Project:	No.1 Portinscale Close, Bury BL8 1DB
Client:	Mr and Mrs Tanner
Comment:	Planning Submission
Date:	Existing and Proposed Street Scene

Contract No.	1255
Dwg No.	2.05
Revision	B
Date	September '20

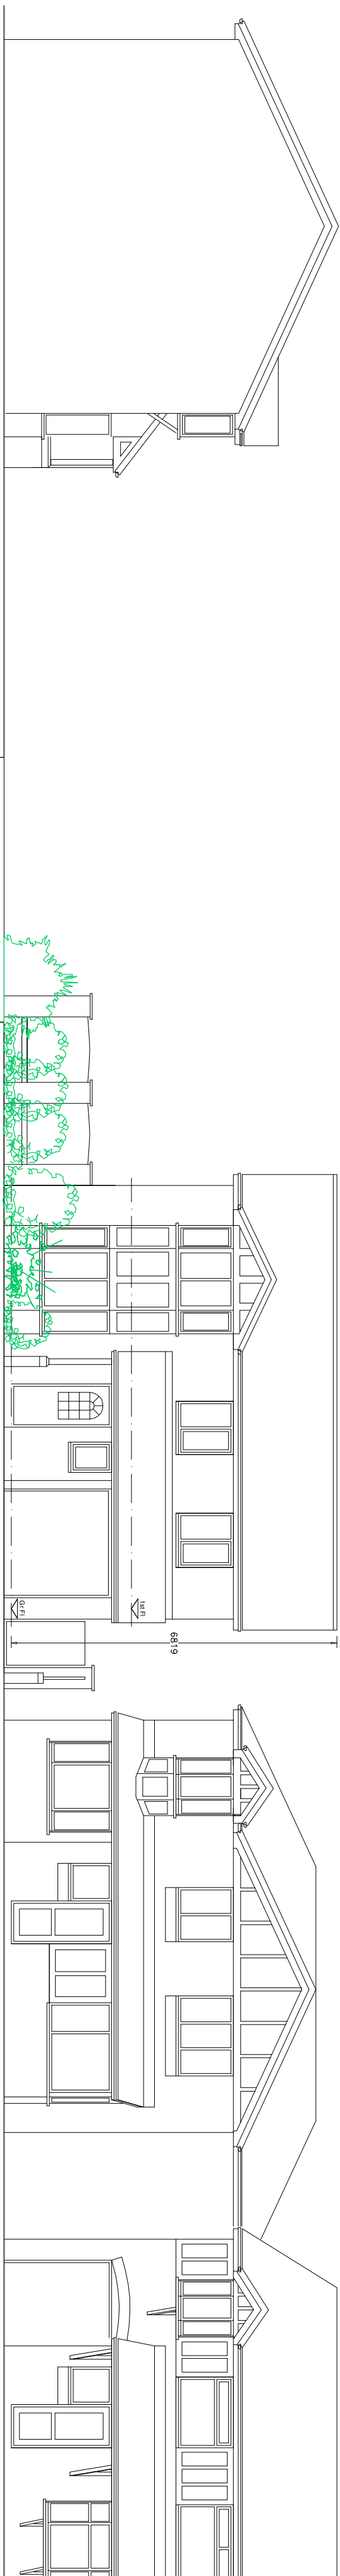
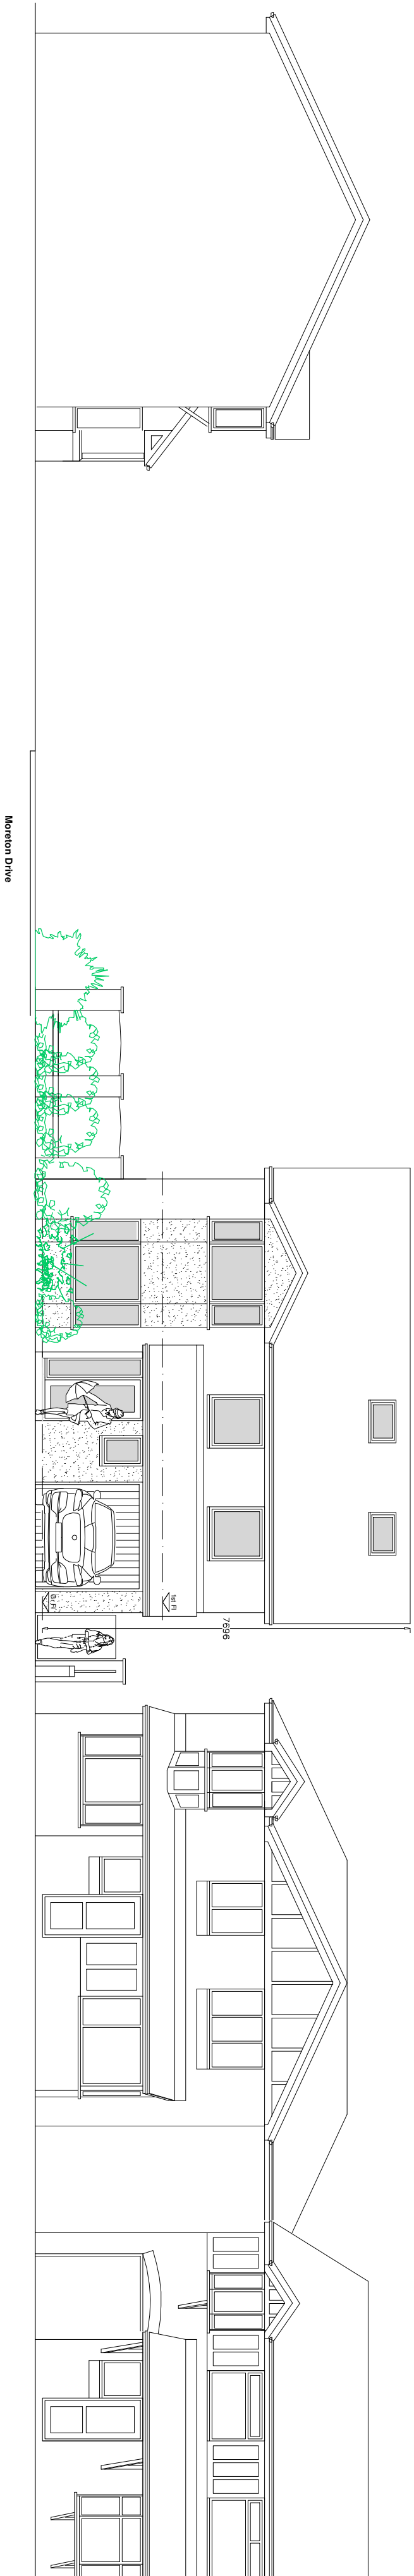
Revision	Notes	Date	Drawn
A	Proposed ridge height lowered by 150mm	17.11.20	
B	Dimensions added to existing and proposed street scene elevations to show ridge height level above existing ground floor level	30.11.20
